**Title & Document Type:** 8502A Transmission / Reflection Test Set Operating and Service Manual

**Manual Part Number:** 08502-90001

**Revision Date:** August 1977

# MANUAL CHANGES

Figure 3. HP Model 11851A Cable Accessory Set

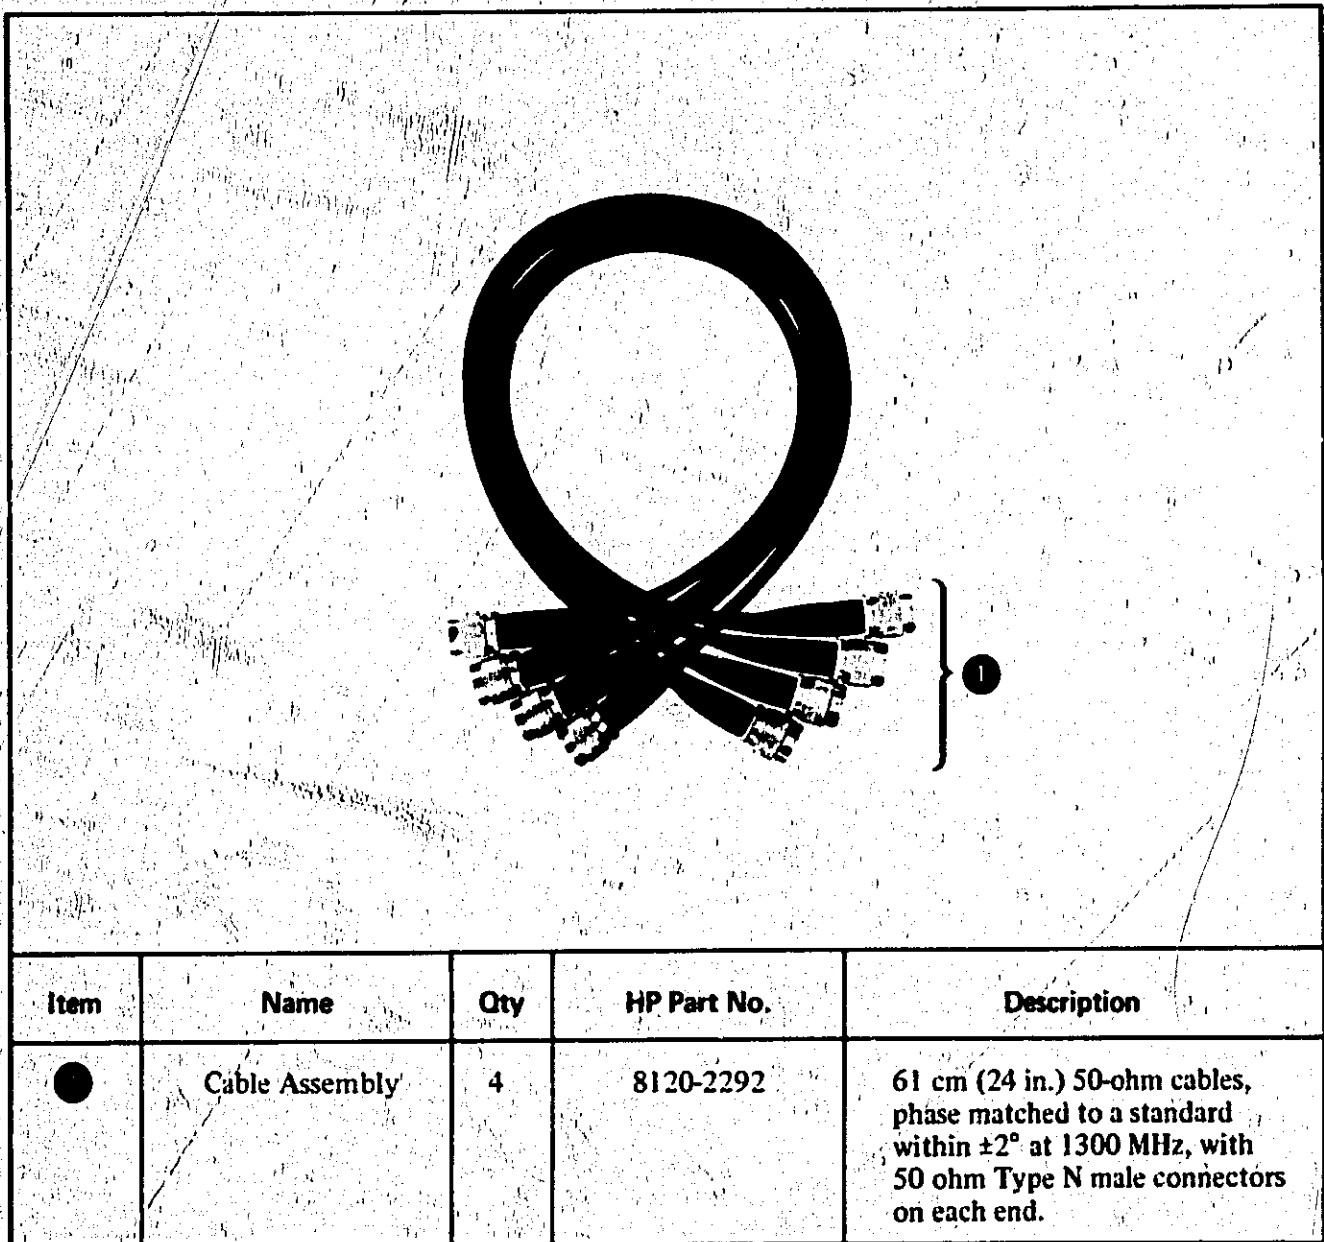
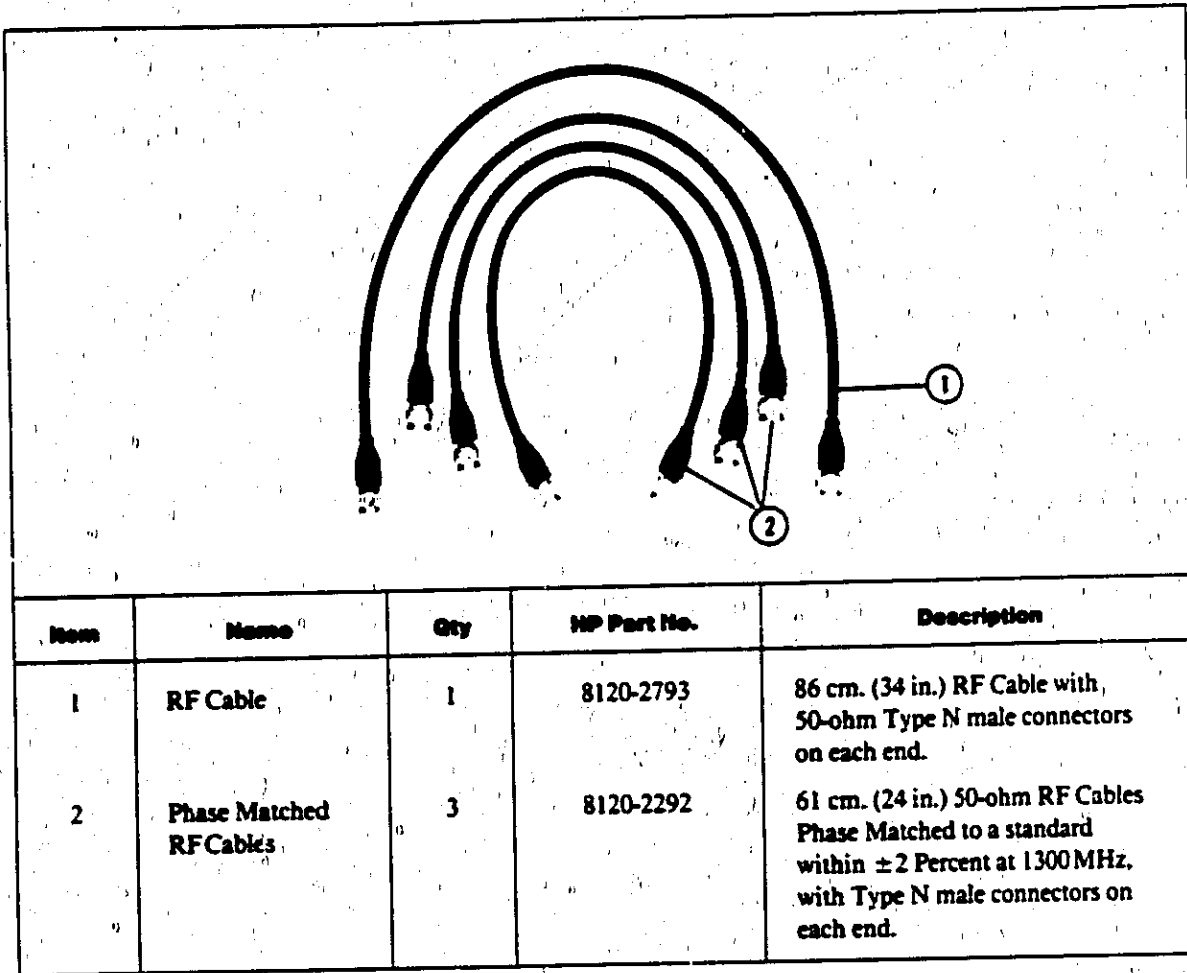
Change this paragraph to read: Hewlett-Packard Cable Accessory Set 11851A, shown in Figure 3, contains four cables. Three of these are phase matched to a standard, and are available individually. These cables help provide accurate measurements when using the HP 8505A Network Analyzer and other instruments.

Replace Figure 3 with the HP 11851A Cable Accessory Set figure supplied in this Change Sheet.

Figure 27. Model 8502A Transmission/Reflection Test Set Equivalent Circuit (CHANGE 4)

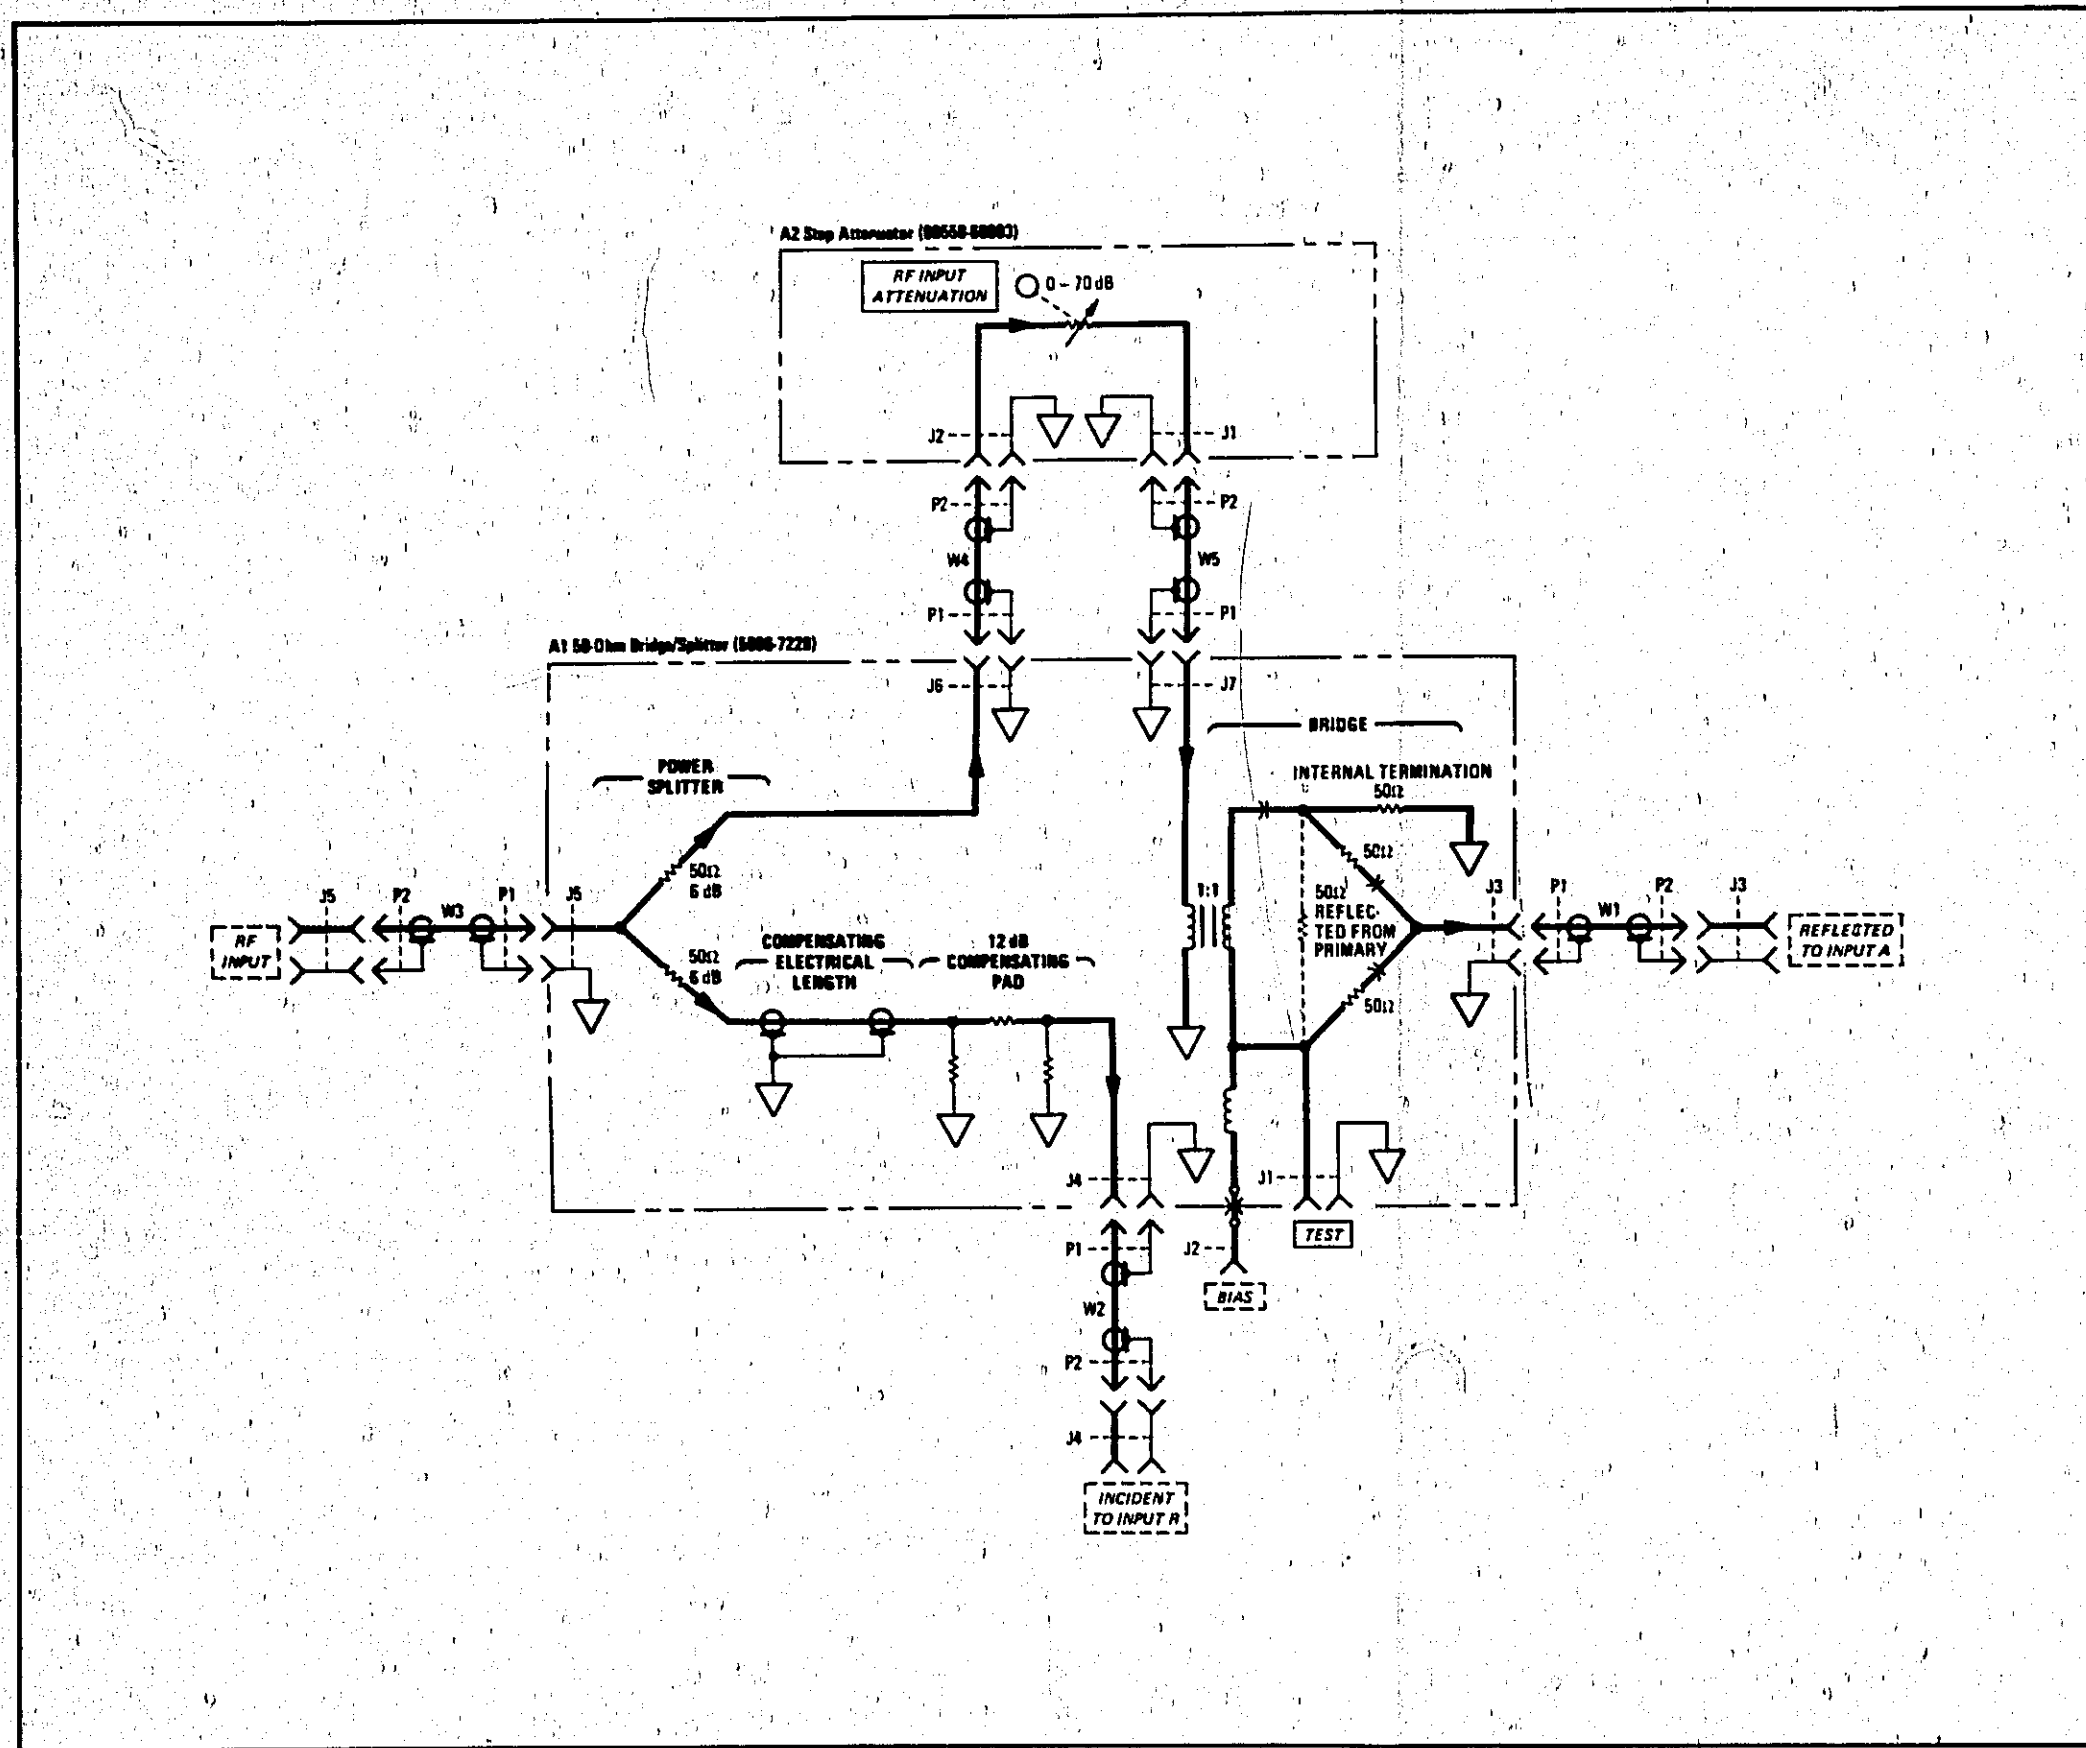
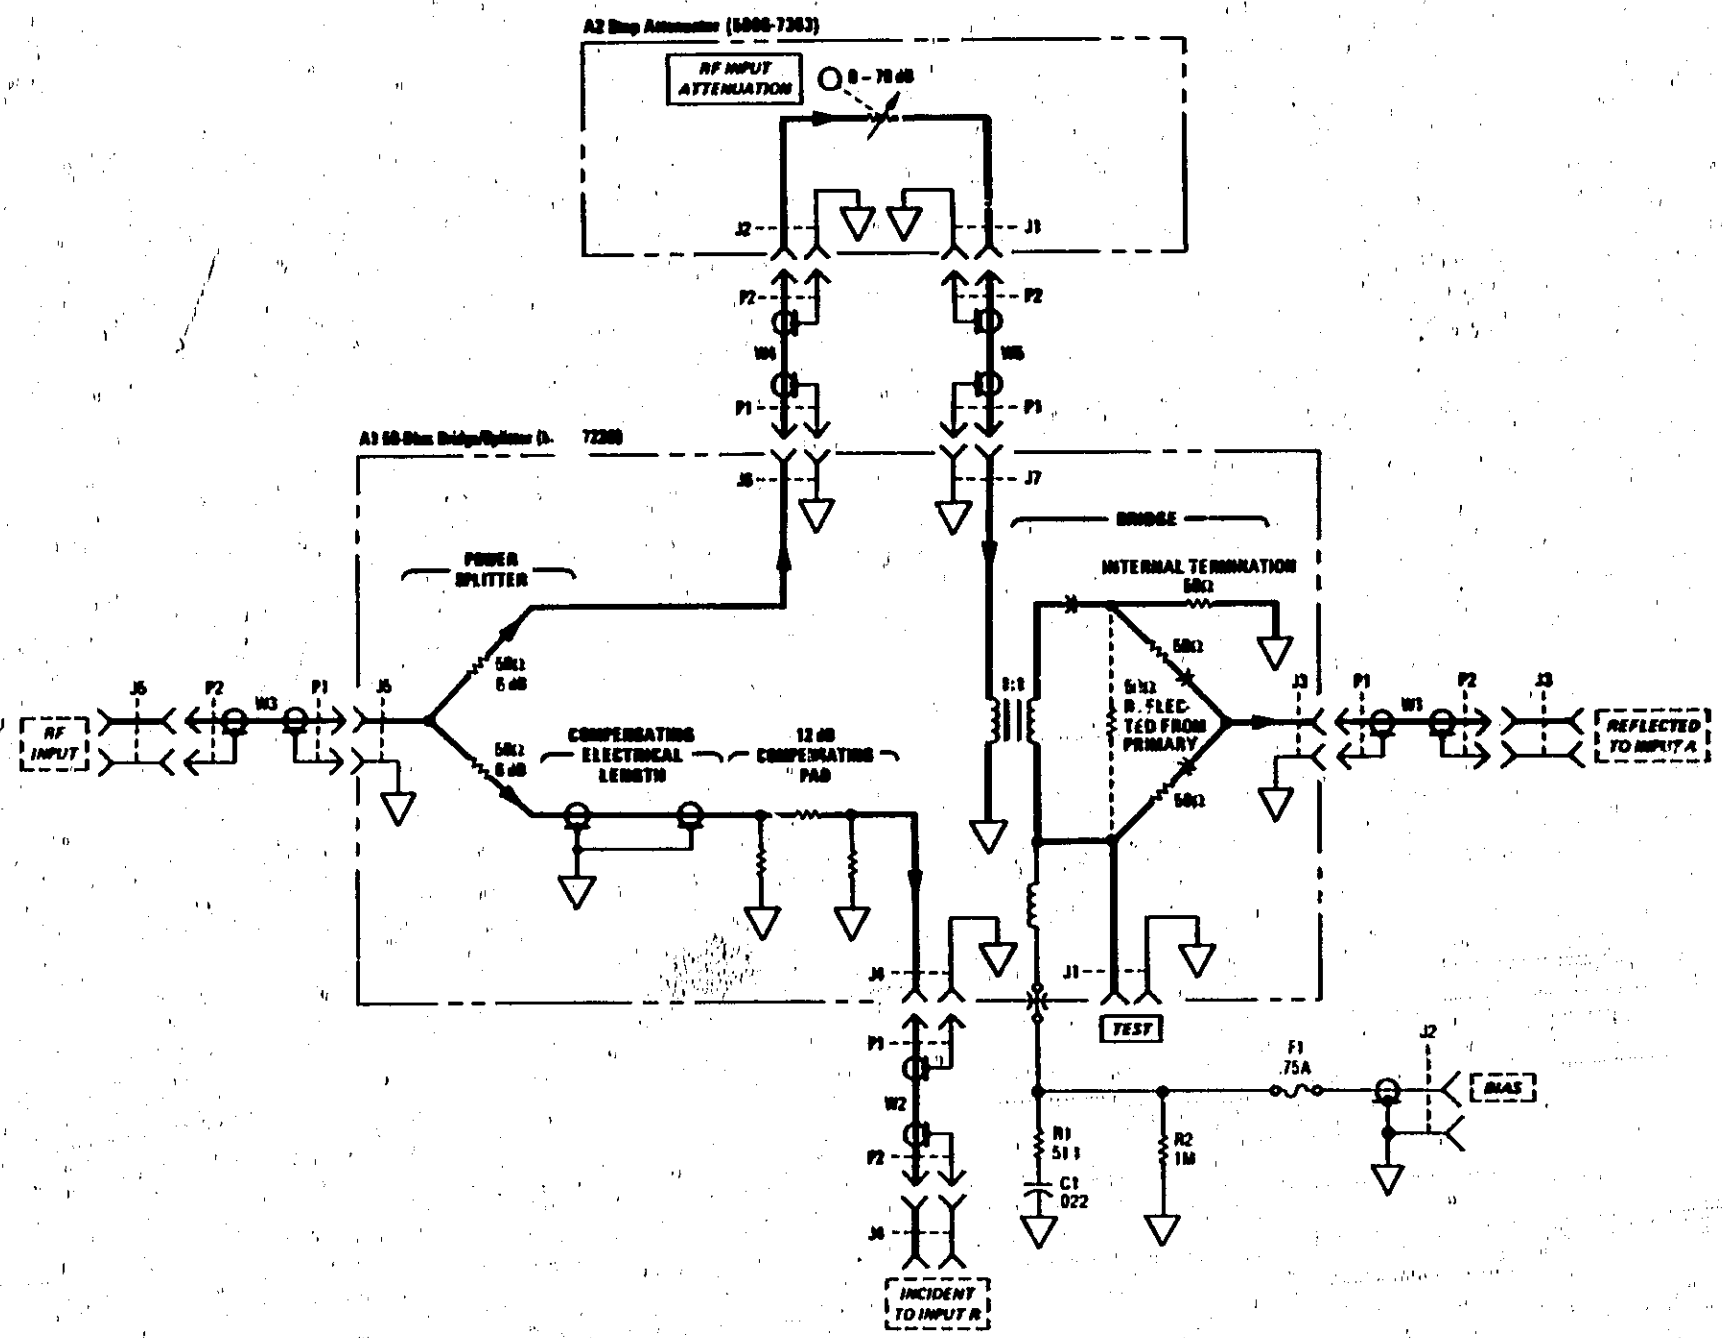
Replace Figure 27 with the Model 8502A Transmission/Reflection Test Set Equivalent Circuit diagram supplied in this change sheet.

Add C2, having HP Part Number 0160-4833. CD5. CAPACITOR-FXD .022UF  $\pm 10\%$  100VDC CER.

Add F1, having HP Part Number 2110-0424. CD9. FUSE .75A 125V NTD .25X.27.

Add R1, having HP Part Number 0757-0394. CD0. RESISTOR 51.1 1% .125W F TC= $0 \pm 100$ .

Add R2, having HP Part Number 0698-8827. CD4. RESISTOR 1M 1% .125W F TC= $0 \pm 100$ .
